Proposal for Supplement 1 to the 02 series of amendments to UN Regulation No. 138

The text reproduced below was prepared by the experts from the International Organization of Standardization (ISO with the aim to reflect the latest status of the ISO/FDIS 16254 draft into R138 and to reflect the understanding of the intent of the QRTV working group. The amendment is based on formal document GRBP/2024/2. The proposal reflects the situation and input from ISO that due to the timing of the development of the ISO/FDIS draft and GRBP/2024/2, it was not possible to have the necessary review and vetting of the GRBP/2024/2 text, and ISO would deliver an informal document with any changes necessary. As GRBP/2024/2 already has text prepared in accordance with UN guidelines (bold, strikethrough). This text uses those same guidelines, but only in respect to GRBP/2024/2. Strikethroughs present in GRBP/2024/2 are retained.

4.4.1. Test Method (A)

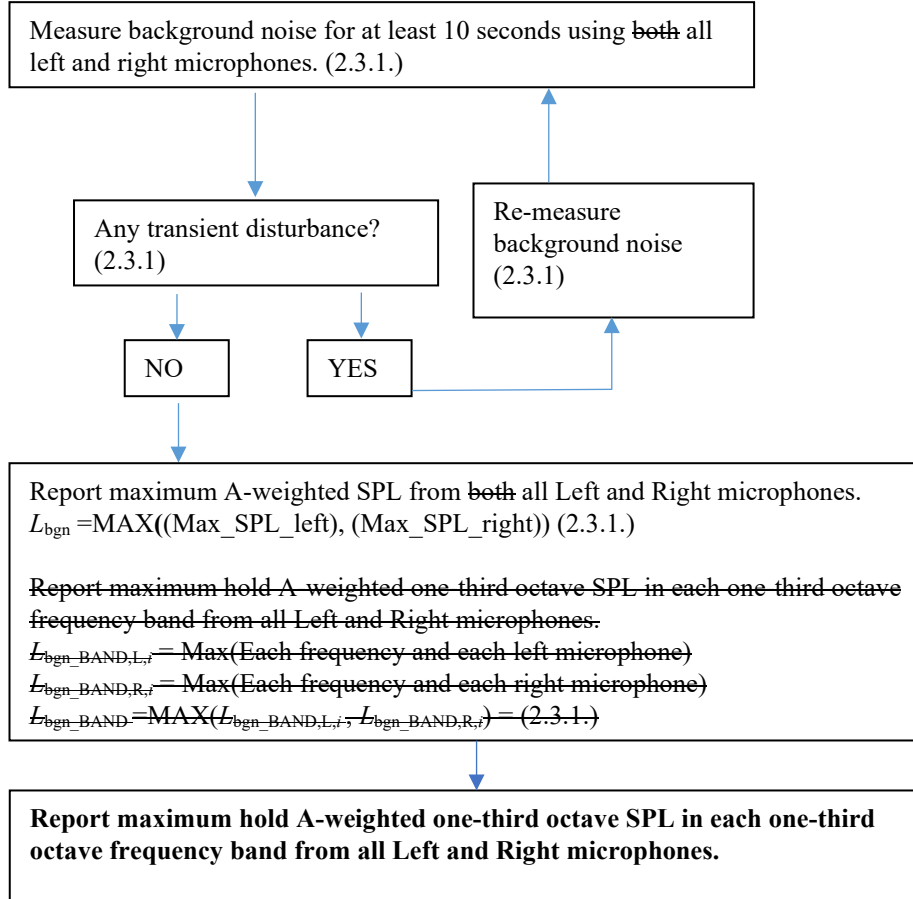
At least four measurements shall be made at every speed specified in paragraph 4.3.1. The emitted sound shall be recorded during each passage of the vehicle between AA' and BB' for each microphone position.

~~For minimum sound requirements~~ From each measurement sample a segment taken from AA until 1 meter before PP' shall be ~~cut out~~ used for further analysis.

~~For maximum sound requirements for each measurement sample a segment taken from AA until PP' plus vehicle length be cut out for further analysis.~~

8. Clarify the measurement zone needed for frequency shift measurement. Remove specification regarding maximum sound levels as they do not belong in the frequency shift section. Maximum sound levels are now described in paragraph 3.4 of Annex 3.

Flowchart for the procedure to measure and report overall A-weighted sound pressure levels

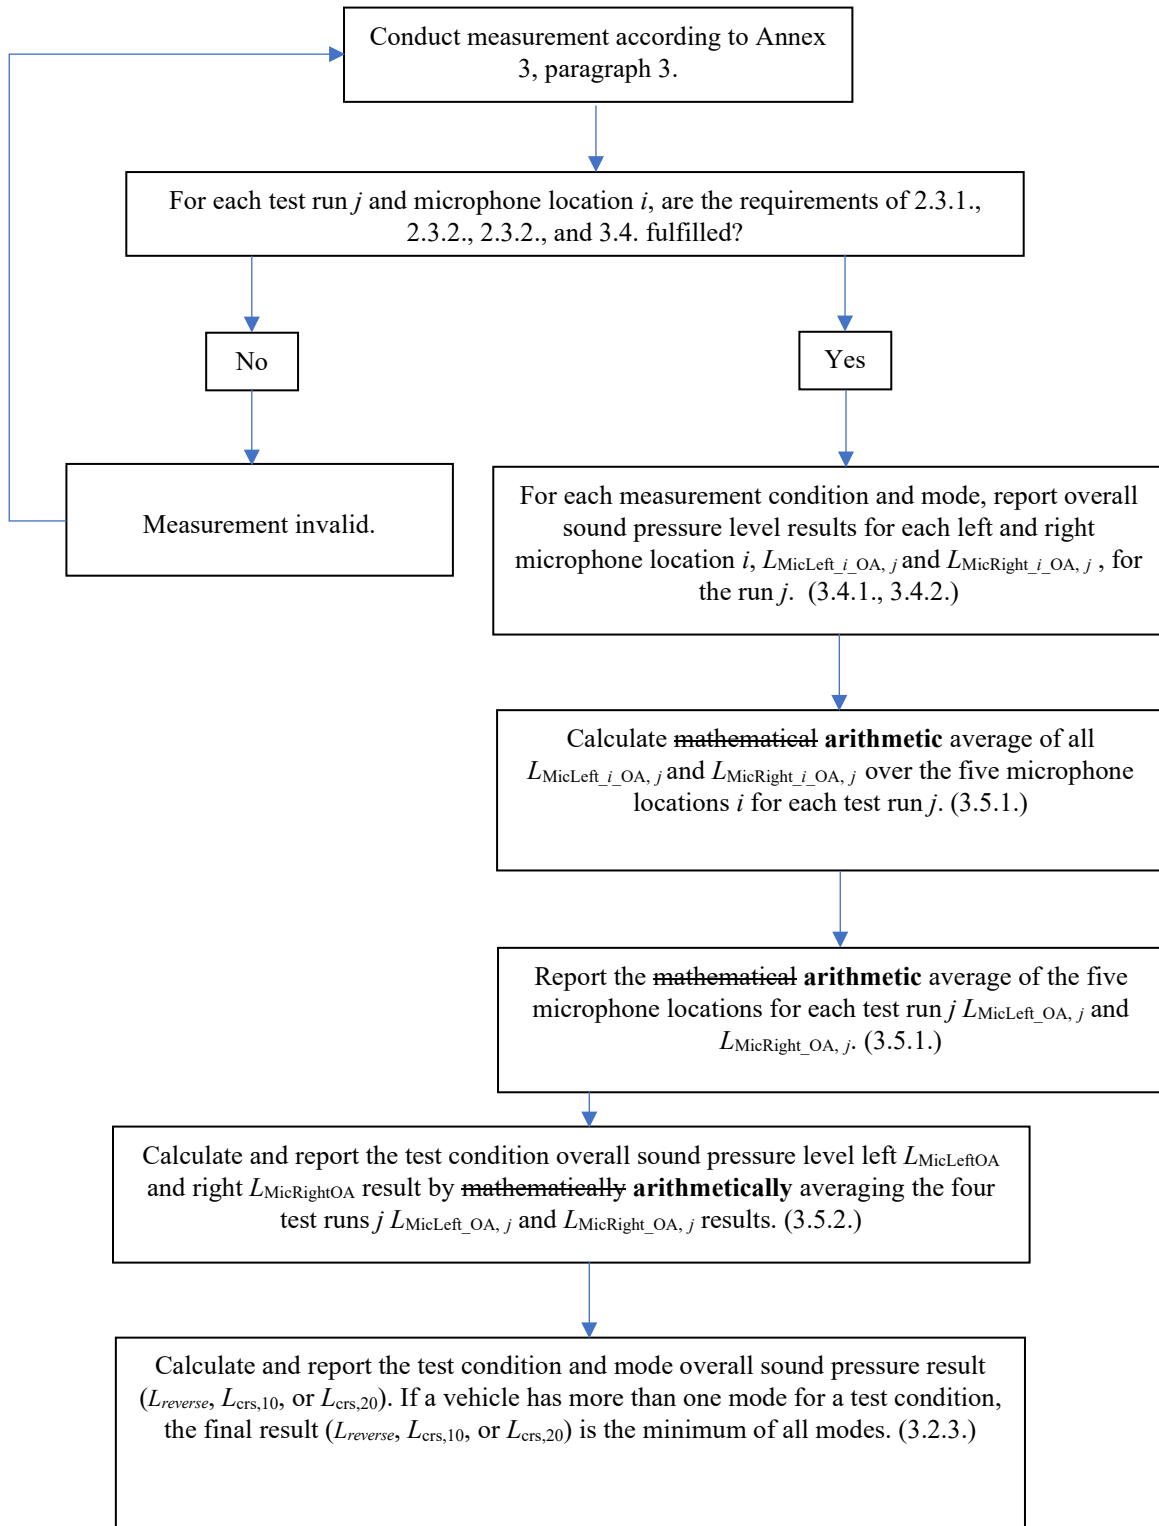
The purpose of Figure 6 is to show how to go from the five microphone results for each measurement run to a final answer. It conceptually has two major steps:

- 1) First reduce the five microphones to a single result for each measurement run j . In this case, the maximum overall sound pressure level in each microphone i is arithmetically averaged to produce the final result.**
- 2) Average the four j measurement runs to provide the final answer for the test condition and mode.**

10. Add explanatory text to flowchart. Revised “mathematical” to” arithmetical” to avoid misunderstanding of which mathematical process to use.
 11. Fix error that overall sound pressure levels were specified when one-third octaves are the correct result to be calculated. Also added explanatory text to the flowchart. Revised “mathematical” to ”arithmetic” to avoid misunderstanding of which mathematical process to use.
-

Figure 7.
Flowchart for the procedure to measure and report A-weighted one third octave sound pressure levels

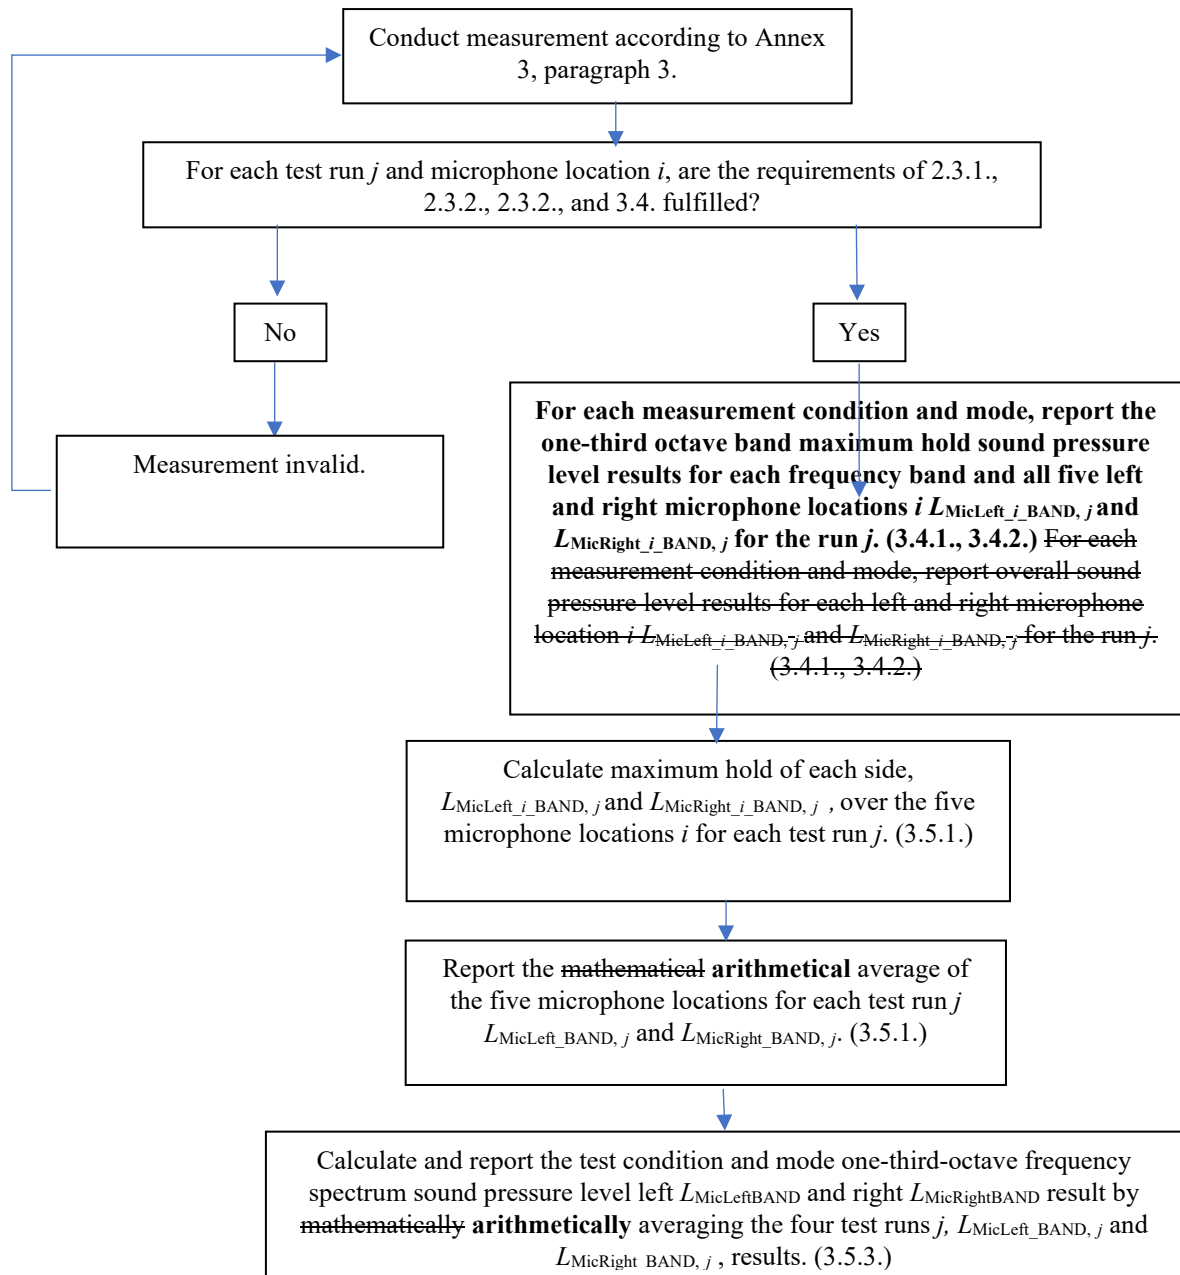
The purpose of Figure 7 is to show how to go from the five microphone results for each measurement run to a final answer. It conceptually has two major steps:

- 1) First reduce the five microphones to a single result for each measurement run j . In this case, the maximum one-third-octave sound pressure level in each frequency in each microphone i is measured. Then these five spectra are again reduced to a single spectrum by taking the maximum one-third-octave sound pressure level in each frequency. The result is then the reported frequency spectrum for a given test run j .
- 2) Average the four j measurement runs to provide the final answer for the test condition and mode.
